# Interactive comment on "Reconstructing the Salgar 2015 Flash Flood Using Radar Retrievals and a Conceptual Modeling Framework: A Basis for a Better Flood Generating Mechanisms Discrimination" by Nicolás Velásquez et al.

# Response to Reviewer 2

**Manuscript title:** Reconstructing the Salgar 2015 Flash Flood Using Radar Retrievals and a Conceptual Modeling Framework: A Basis for a Better Flood Generating Mechanisms Discrimination

**Fig. 3.** Temporal evolution of discharge during Event 2 in different locations along the watershed's main channel. The upper location corresponds to 15% of the area of the basin, and the other downstream locations to 52%, 76%, and 100% of the watershed, respectively.

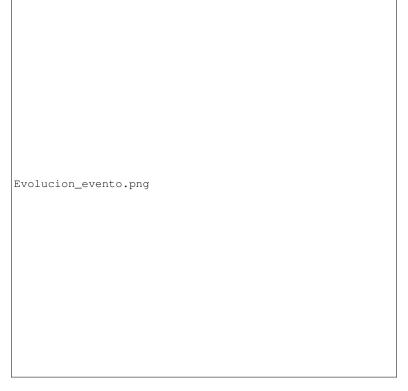
P19L494 It is essential for the second event, according to the spatial rainfall heterogeneities, to provide some distributed simulation results: what part of the flood volume has been produced on the 15% upstream part of the watershed? Is the contribution form the intermediate watershed significant?

Considering the reviewer comments, we decided to add an additional Figure for Event 2. Figure 3 shows the temporal evolution of discharge during Event 2 in different locations along the watershed's main channel. The upper location corresponds to 15% of the area of the basin, and the other downstream locations to 52%, 76%, and 100% of the watershed, respectively. In terms of volume, 73

Mm³ of the total 144 Mm³ simulated at the outlet of the basin are generated on the 15% upstream part of the watershed, corresponding to about half of the total mass. In terms of peak flow, due to the slope and velocity changes, the simulated discharge at the 15% upstream part of the watershed corresponds to 61% of the peak discharge at the outlet of the basin.

Fig. 5. Event 2 simulated varying the percentage of capillary storage in the initial conditions.

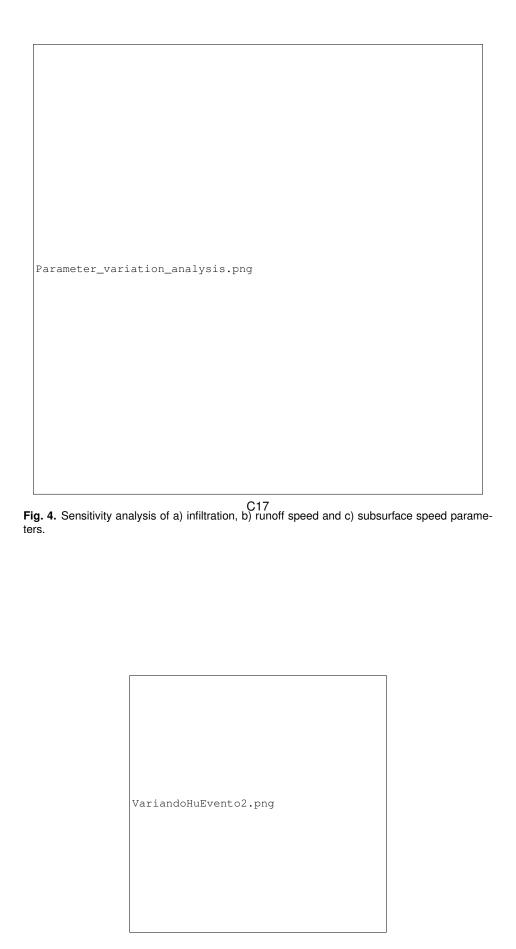
P22L562 Why should the soils be wet upstream since this area has not strongly been affected by the first rainfall event?

As mentioned before, and as shown in Figure 5 in the revised manuscript, there is rain in almost all the basin during Event 1, about 21 mm in the upper part of the basin. Also, from Figure 10 in the revised version, we can see variations in the capillary and gravitational storages associated with Event 1 in the higher numbered groups. The capillary storage remains high in almost all the basin until the start of the second event. According to the conceptualization of the model, the gravitational storage and surface runoff start to interact when the capillary storage is full. In this case, this situation is set up by Event 1. We also made some evaluations for Event 2 using dry initial states, with no flooding in the results (Figure 5).
